GUIDE PAGE - REPORT TES-3210

This is the Guide Page to update report TES-3210 to Revision 2, December 1991.

**RESUBMITTAL OF PRIOR APPLICATIONS
AND SUPPLEMENTS FOR APPROVAL TO
TRANSPORT THE SENTINEL (LOG) - 25C
RADIOISOTOPE THERMOELECTRIC GENERATOR
AS A TYPE B () PACKAGE**

REVISION 2

FIGURE E-1. SENTINEL 25C IN SHIPPING CONFIGURATION

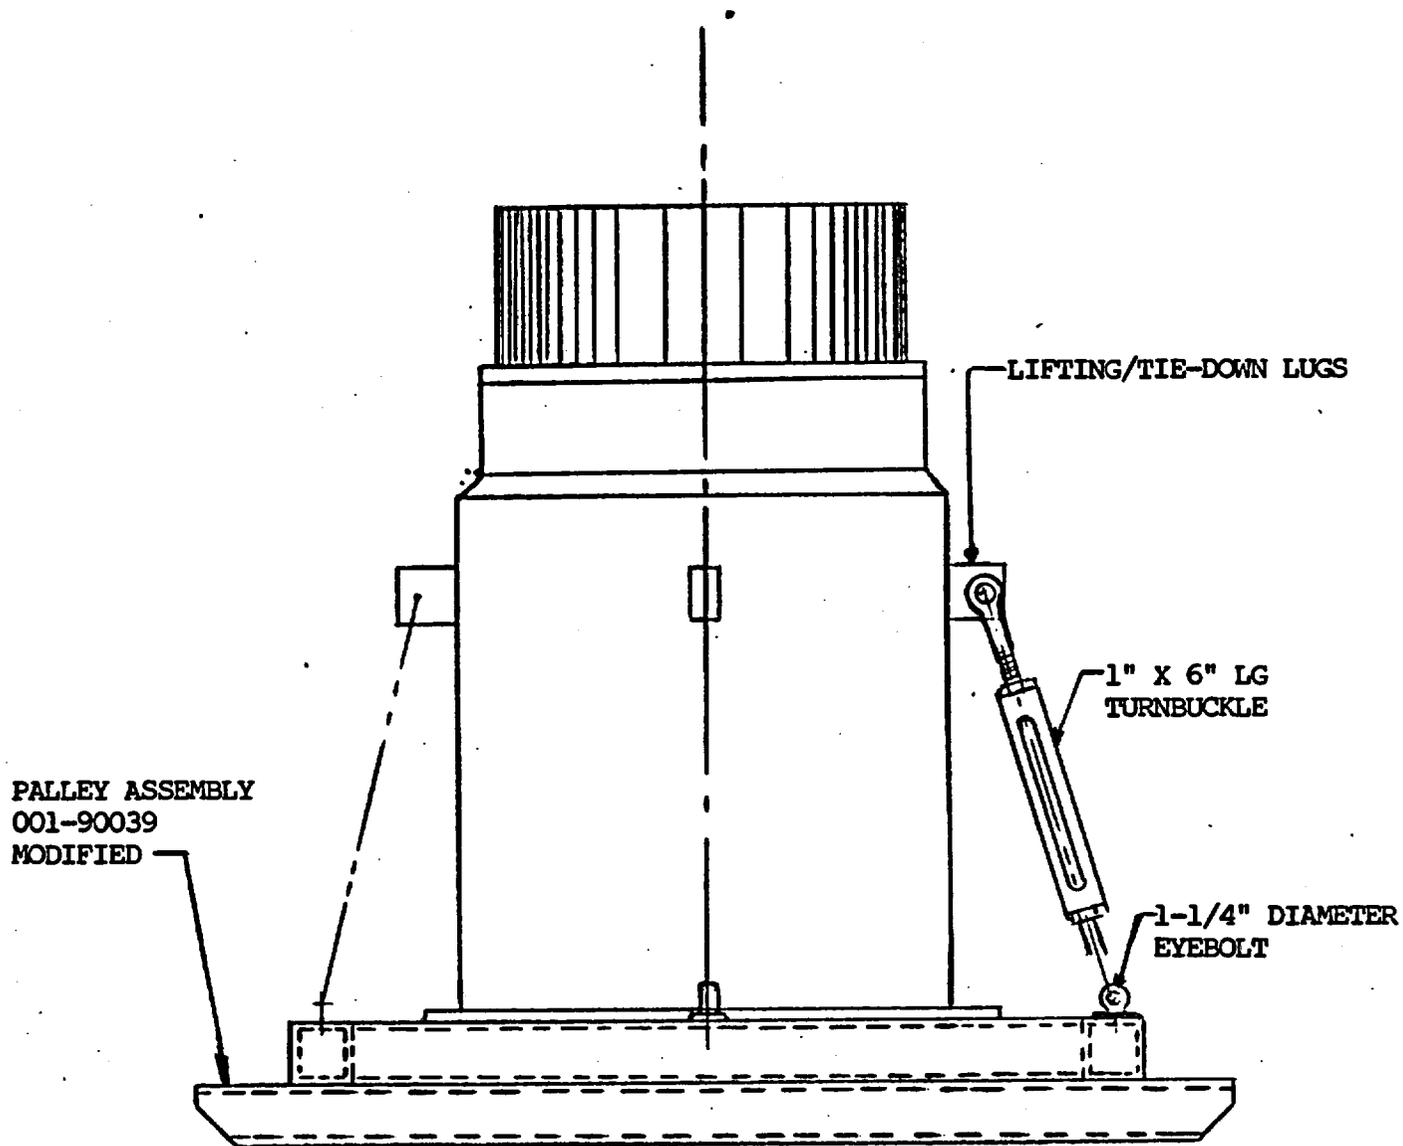
- b. Insure that the "shorting plug" furnished with the RTG is installed, when the RTG is disconnected from its electrical load.
- c. Insure that the RTG is properly installed on its steel shipping pallet and tied down with the hardware shown on Figure E-1. Note that the Sentinel 25C is the only RTG in the entire Sentinel 25 series of generators that is not bolted directly to the steel pallet but is attached by means of turnbuckles. The shipping pallet was modified by the user and the attaching hardware provided as "government furnished equipment." General arrangement of hardware, however, is shown in Figure E-1 and the torque should be limited to 85-90 foot pounds.

The hardware that attaches the RTG to its shipping pallet (see Figure E-1) should be inspected prior to each shipment for signs of corrosion, structural damage and other forms of deterioration. The hardware must be replaced with new hardware if structural integrity is in doubt.

FIGURE E-2. PALLET TIE-DOWN CONFIGURATION

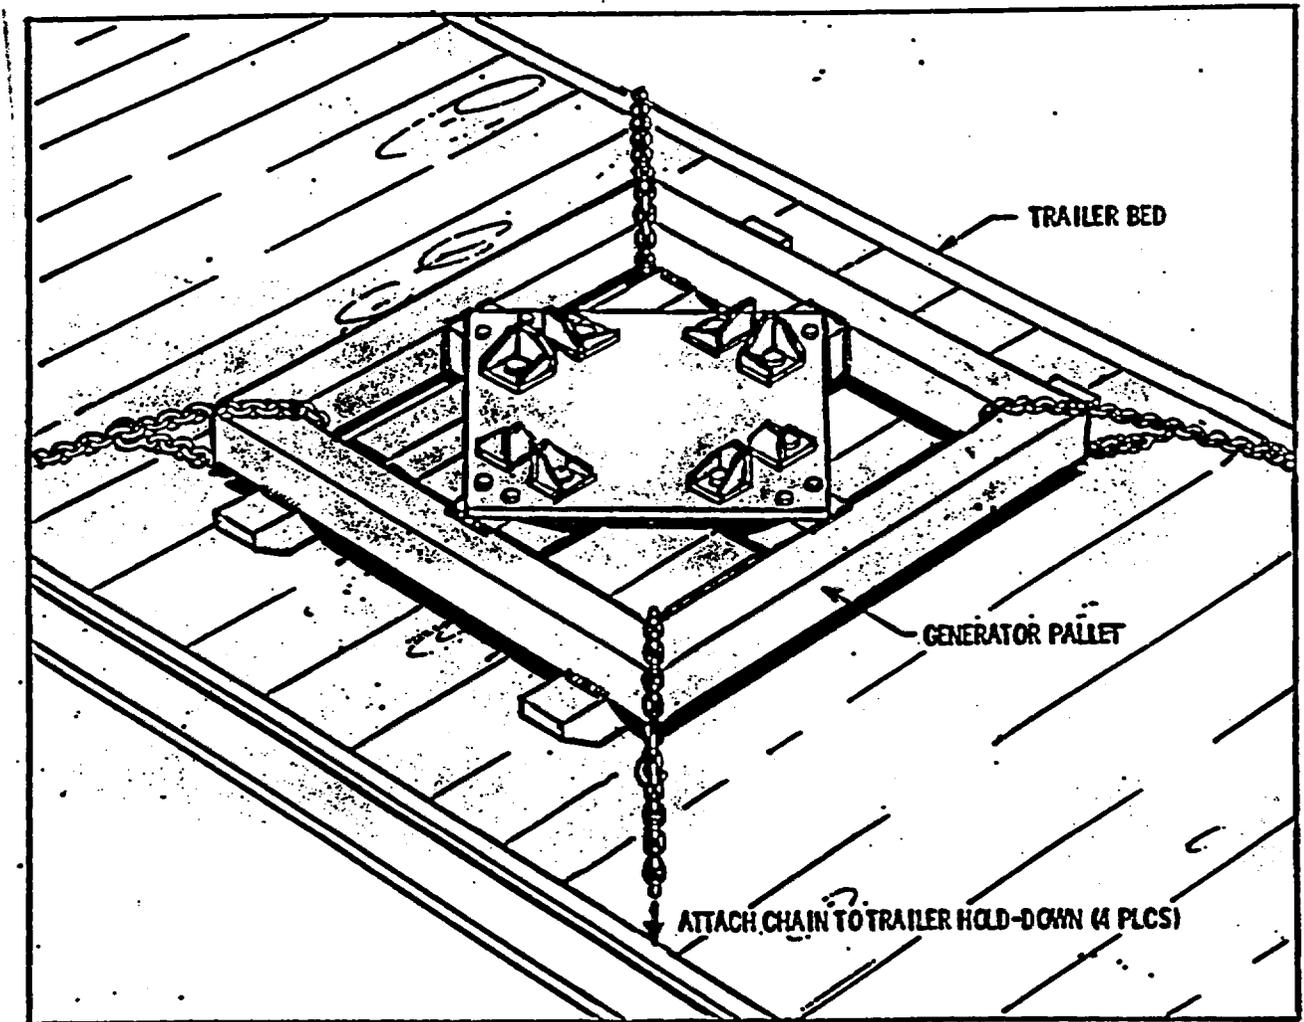
The RTG, when loaded for shipment is to be tied down in a configuration similar to that shown in Figure E-2. In addition, the RTG must not be covered and should be kept at least one foot from bulkheads, other cargo and any other obstructions which might restrict the flow of air around the generator.
